Diagnostic Trouble Codes (DTC) For The Engine Pre-Heat Relay: Supplementary Instructions

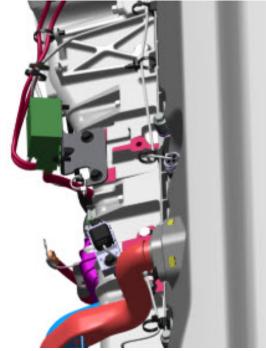
- Nepiace Dout the Fie-Heat relay (F/N 20032004) and the ouppiy Power Cable.

• Install the newly updated bracket design with 2 mounting locations (P/N 24399742). See illustration below.
